Access Compliance Report

Public Rights-of-Way

Intersection ID: 12517	Main Street: N_SHARON_AMITY_RD	Cross Street: SHAMROCK_DR	Location: SW
ADA ID: 128ADA342F1F	Ramp Type: Perp	Initial Pass/Fail: Fail	Overall Compliance: No
Severity Score: 12.5			
Codes/Mitigation Info/Possible Solution		Field Measurements/Component Compliance

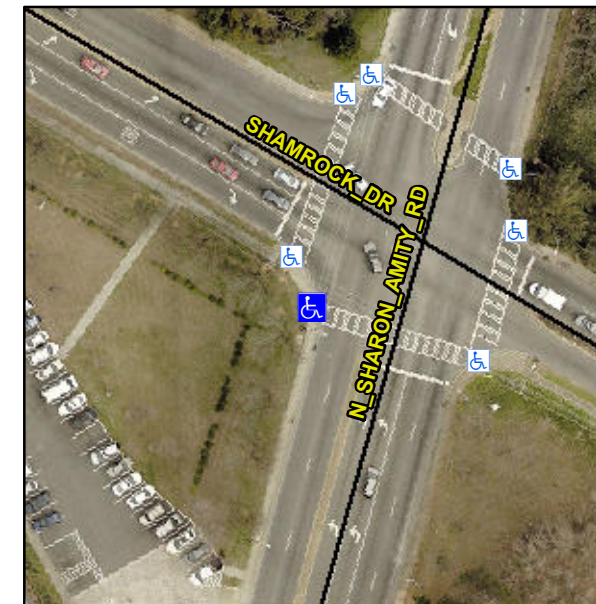
PROW/ADA:

Not Found, R304.2.2

Compliance	Description	Data	Compliance	Description	Data
N/A	Ramp Length (in)	59.0	No	Ramp Slope (%)	9.5
Yes	Ramp Width (in)	48.0	Yes	Ramp XSlope (%)	0.5
N/A	Flare Type LT	N/A	N/A	Flare Type RT	N/A
N/A	Flare Slope LT (%)	N/A	N/A	Flare Slope RT (%)	N/A
N/A	Flare Traversable LT?	N/A	N/A	Flare Traversable RT?	N/A
N/A	Landing Length (in)	N/A	N/A	DWS Provided?	N/A
N/A	Landing Width (in)	N/A	N/A	DWS Contrast?	N/A
N/A	Landing Slope (%)	N/A	N/A	DWS Length (in)	N/A
N/A	Landing X Slope (%)	N/A	N/A	DWS Full Width?	N/A
N/A	Landing Curb? (Y/N)	N/A	N/A	DWS Offset (in)	N/A
N/A	Shared Landing?	N/A			
N/A	Gutter Ponding?	N/A	N/A	Gutter Slope (%)	N/A
N/A	Gutter Lip Ht (in)	N/A	N/A	Gutter X Slope (%)	N/A
N/A	Painted X Walk1?	Yes	N/A	Painted X Walk2?	N/A
	X Walk 1 Direction	To SE		X Walk 2 Direction	N/A
N/A	X Walk 1 Width (in)	104.0	N/A	X Walk 2 Width (in)	N/A
	X Walk 1 Slope (%)	1.2		X Walk 2 Slope (%)	N/A
	X Walk 1 X Slope (%)	0.7		X Walk 2 X Slope (%)	N/A

Remove & Replace Entire Ramp.
